**Addendum No. 1
BL162-23
Harris Elementary School Fire Flow Improvements**

The following addition/changes modify the Bid No. BL162-23 "Harris Elementary School Fire Flow Improvements" Contract Documents, dated November, 2023, as first advertised on November 08, 2023.

Harris Elementary School Fire Flow Improvements

C1.03
PROJ. NO. 36555-17

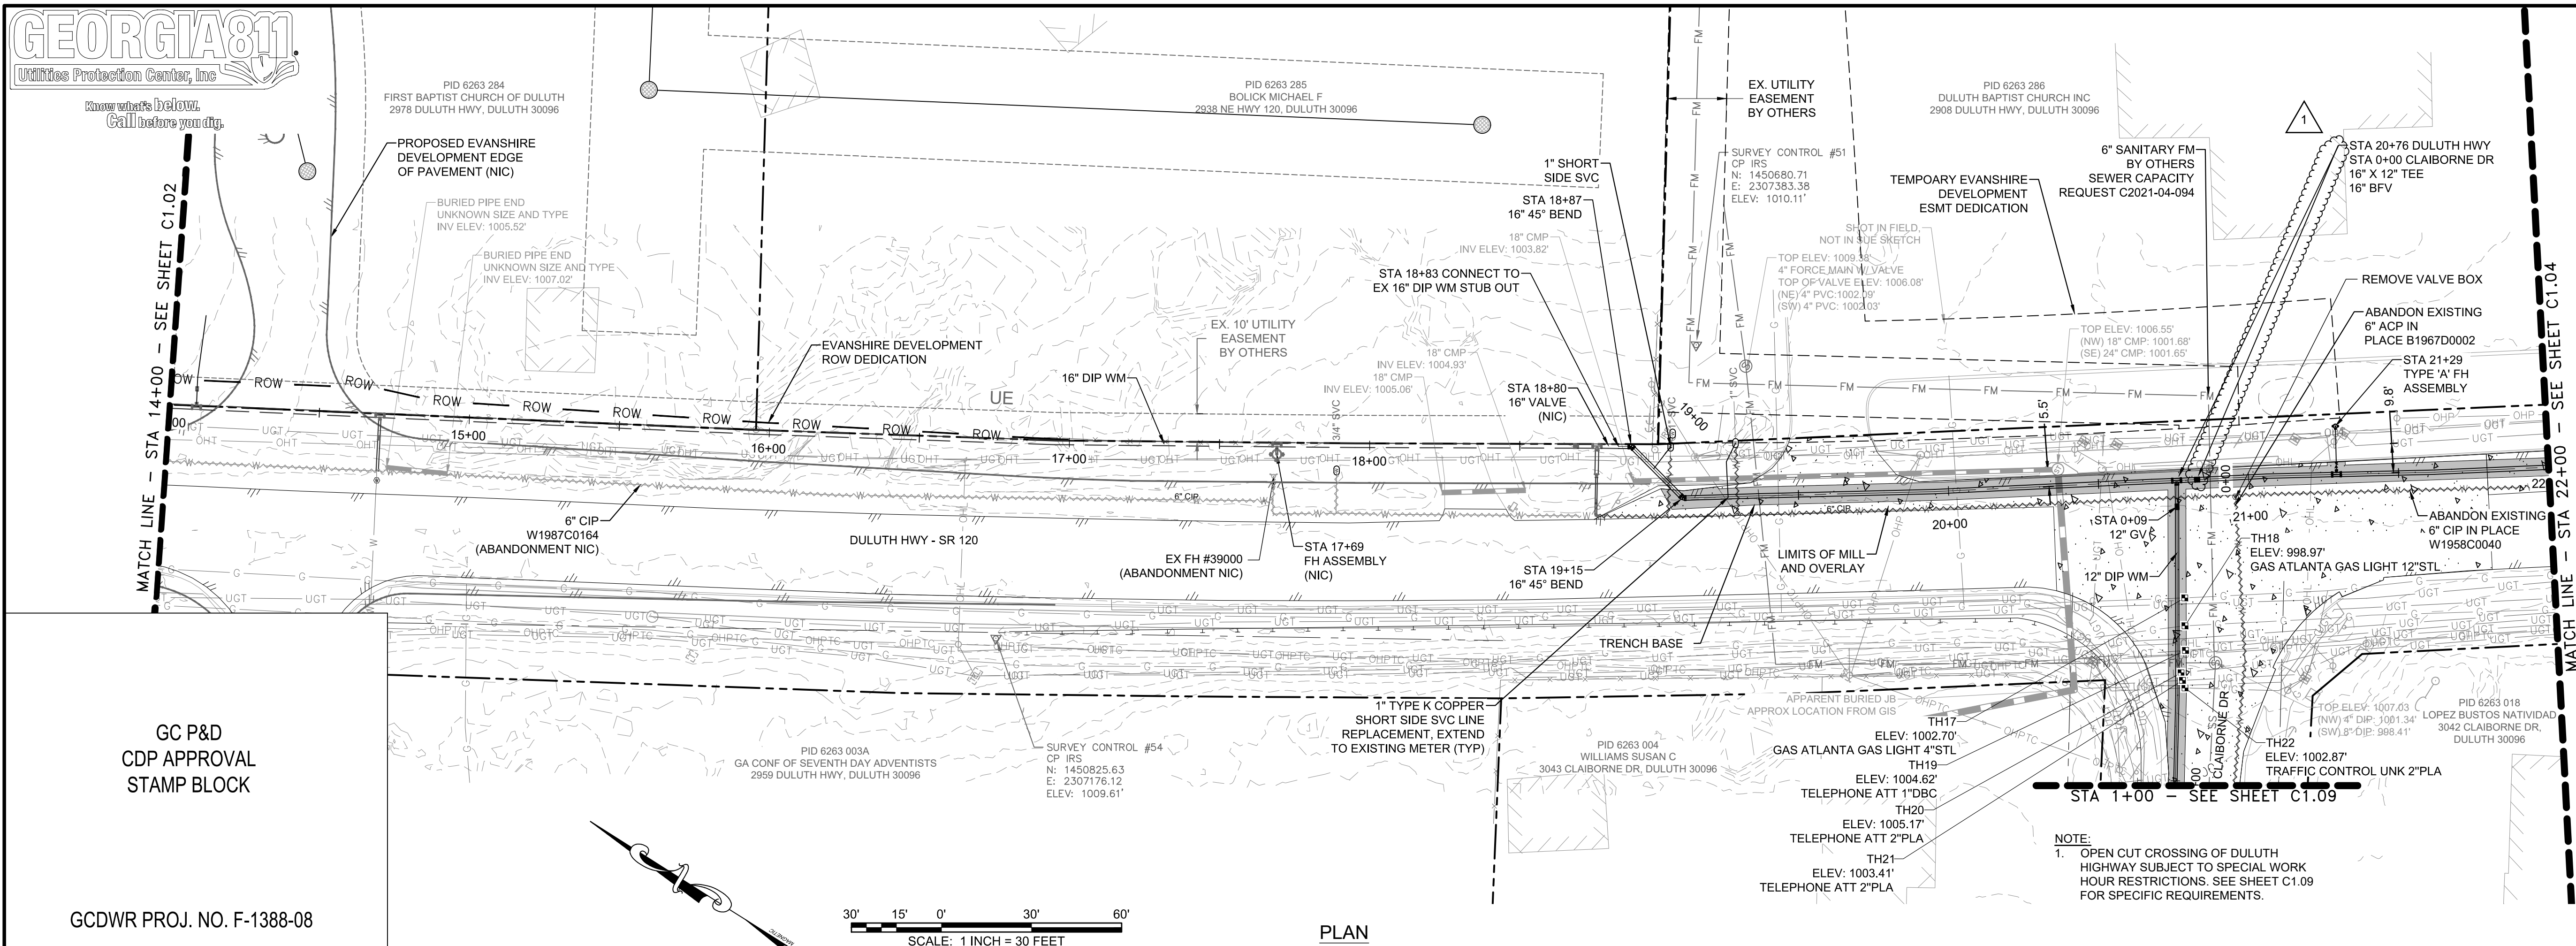
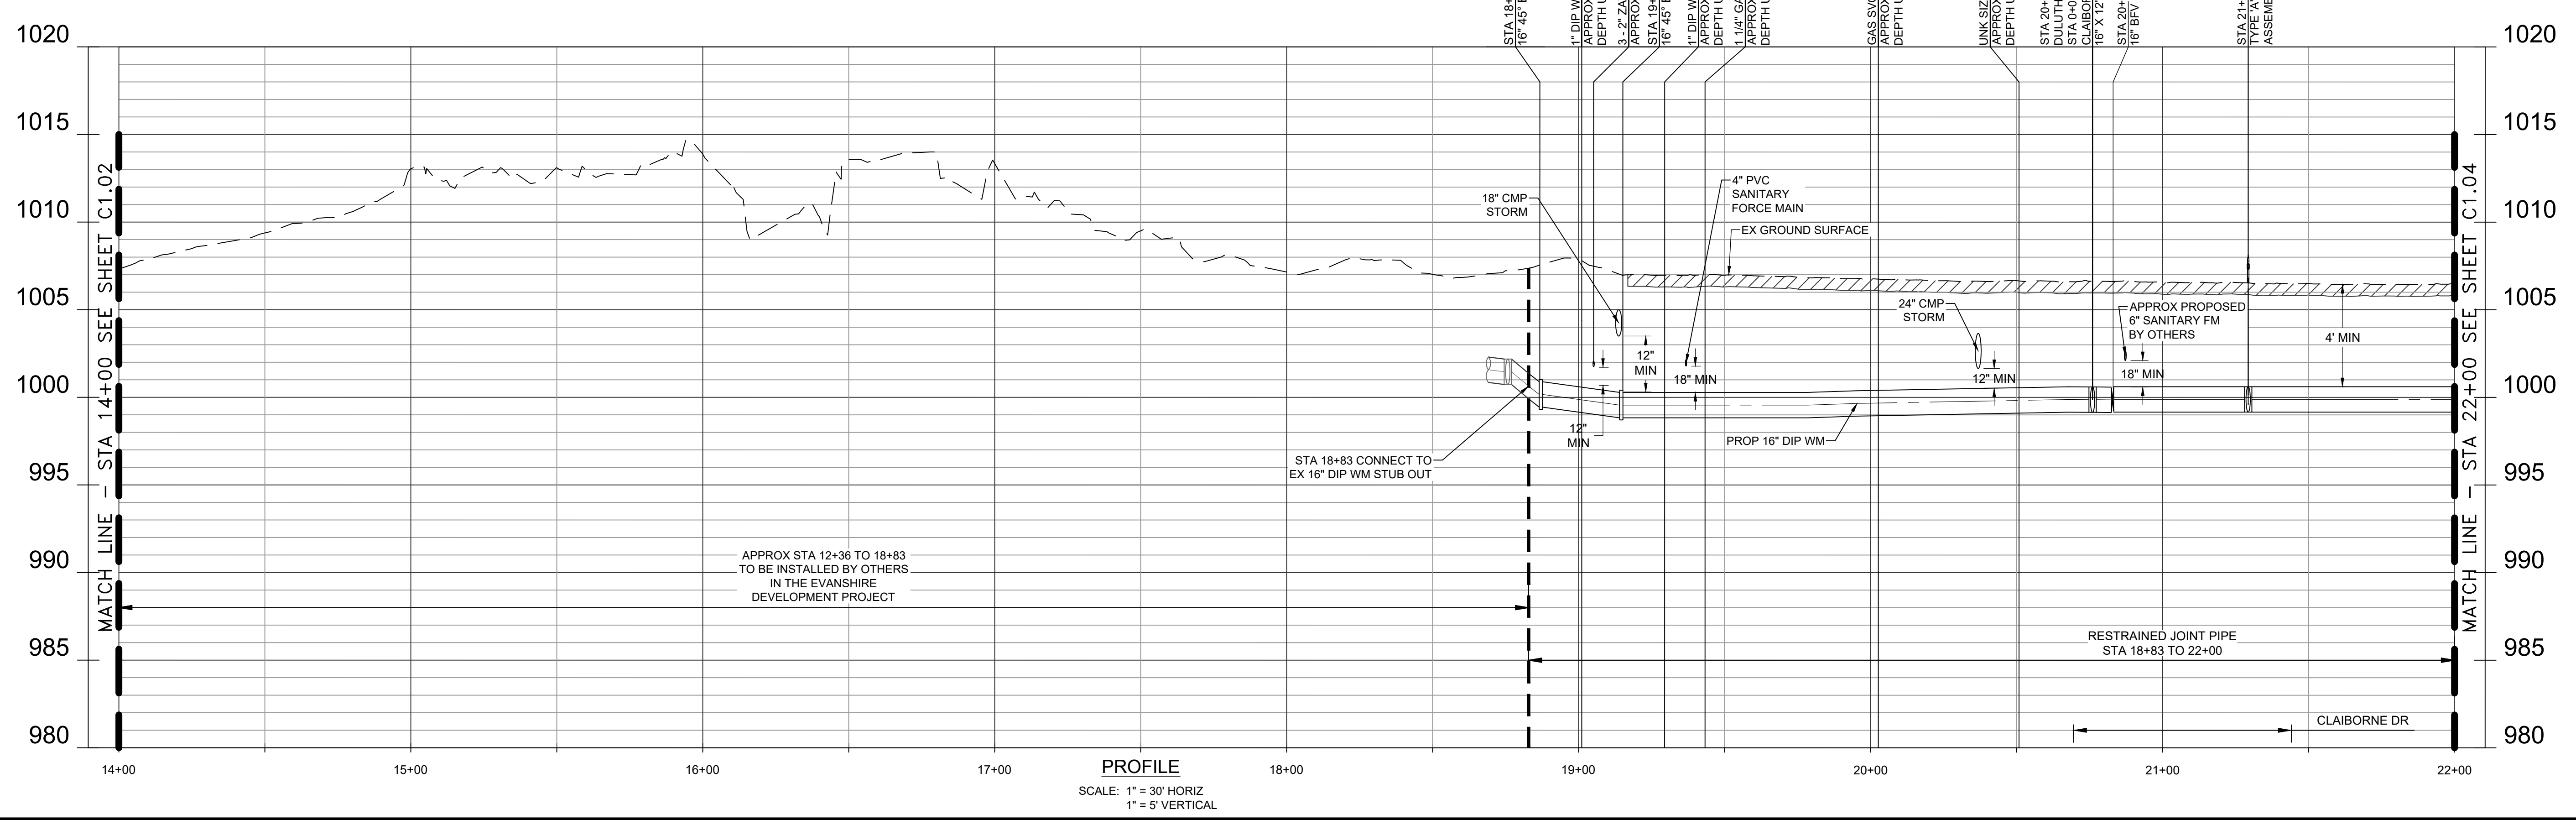
- Q5. Please clarify intentions or note on Page CD 1.03 / 20+76? Location of 16" BFV?
A5. The referenced butterfly valve is shown down station from the tee at 20+76. The callout is combined for the tee and valve due to congested text on the sheet. The intent is to install the 16" BFV immediately down station from the tee. See Item 4 under "Revisions to Drawings" in this Addendum.

4. Drawing C1.03, REPLACE
REPLACE with the attached revised C1.03.
